13 January 2022

ADDENDUM NO. 1

Re: **GS# 354-050**
Tenant Improvement - DMH (1st, 2nd, 10th, 11th and 12th Floors)
Robert E. Lee Building
(Office of Capitol Facilities)
(Department of Finance and Administration)
Jackson, Mississippi

EXHIBIT "A"

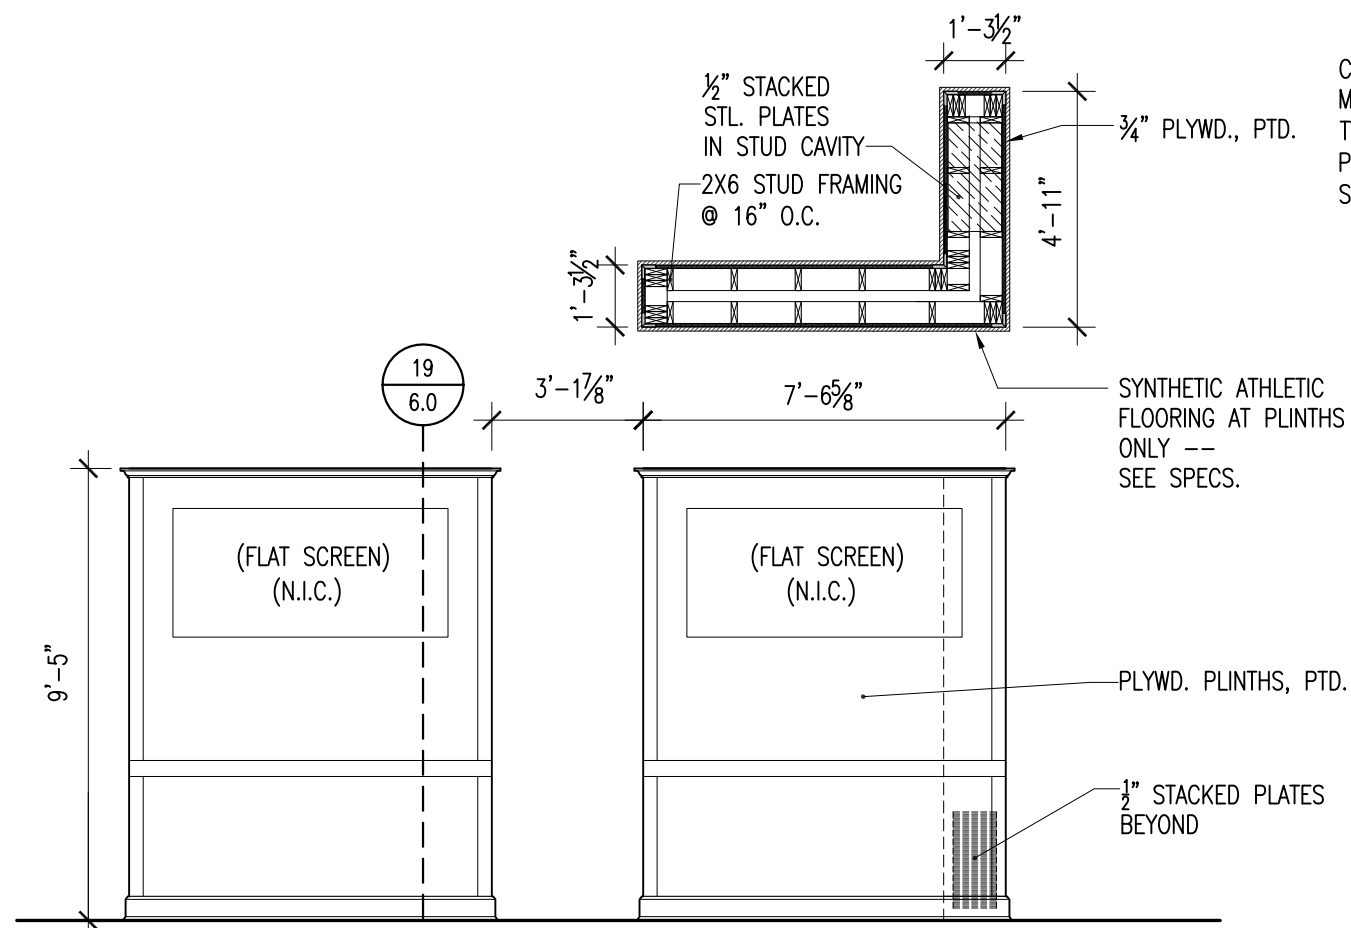
Item No. 1: Refer to Sheet 7.0, elevation "4", and modify as per attached Exhibit "A".

Revised West Side Interior Elev. Front View of Dais Facade

EXHIBIT "B"
SHEET 1 OF 1
(FROM DRAWINGS, SHEET "6.0")

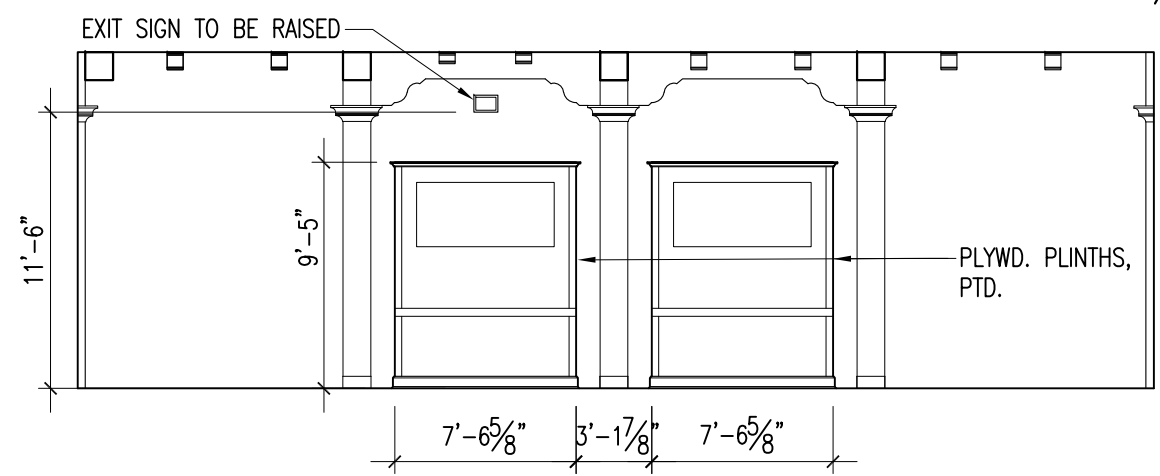
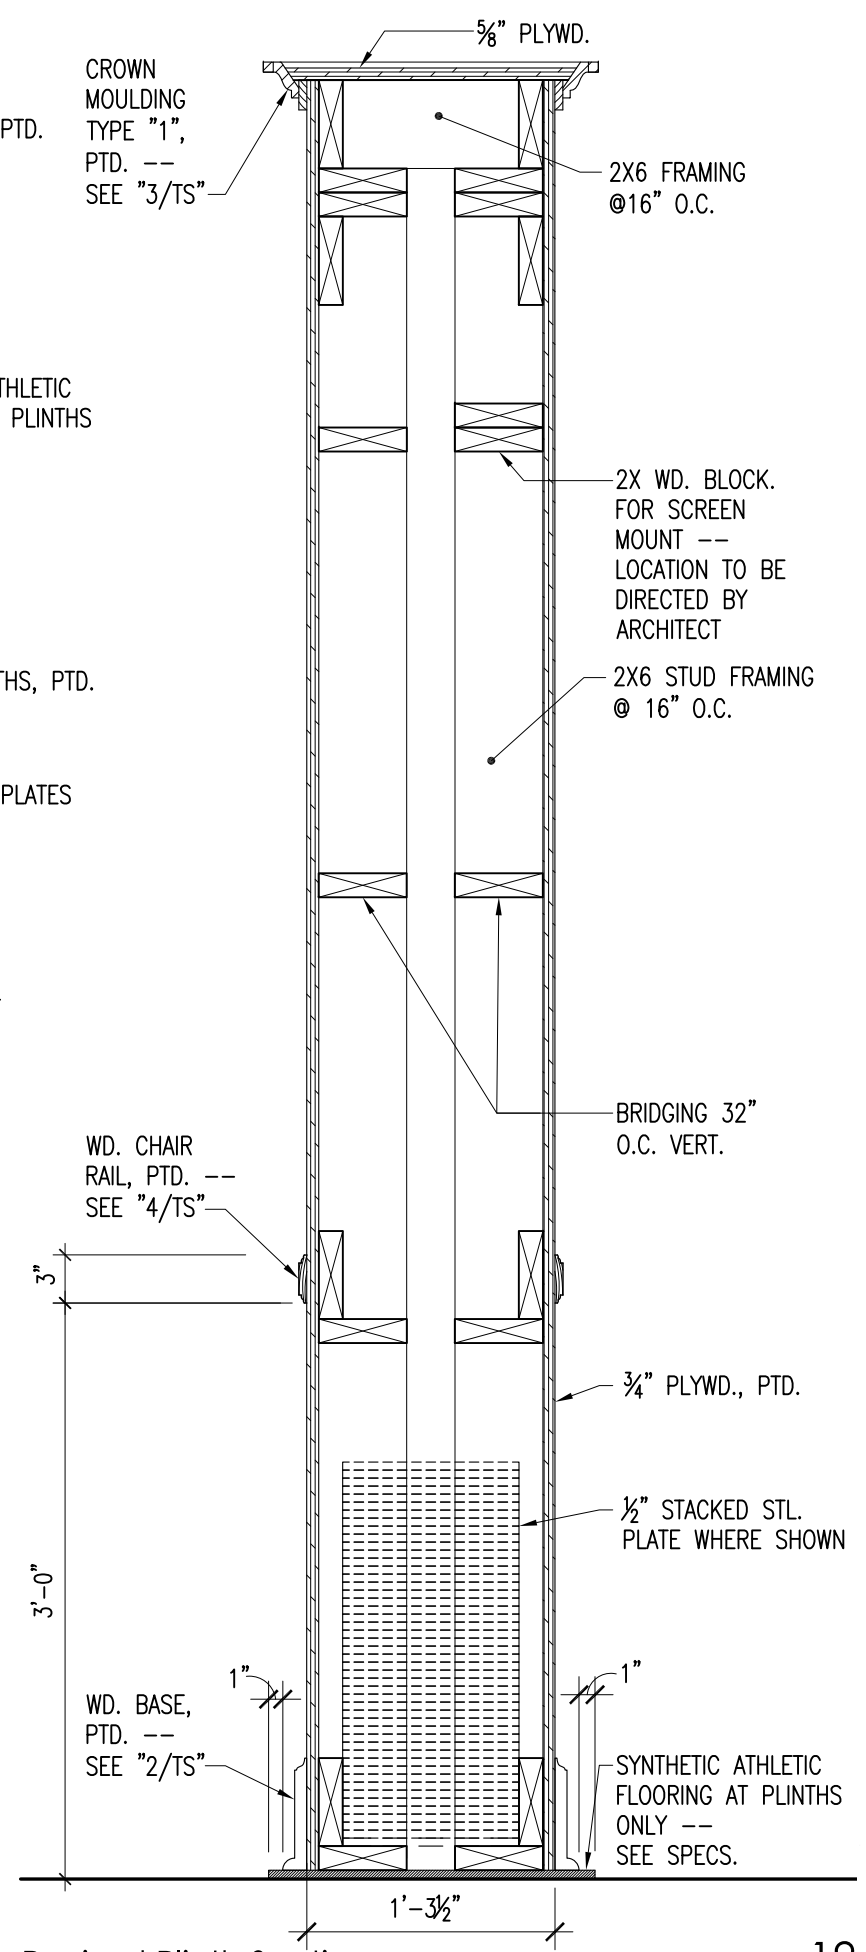
Item No. 2: Refer to Sheet 6.0, elevation "9", elevation "10" and section "19" and modify as per attached Exhibit "B".

Revised West Side Interior Elev. Front View of Dais Facade 9
1/4"

Revised Garden Room Interior Elevation 10
1/8"

Revised Plinth Section 19
1"
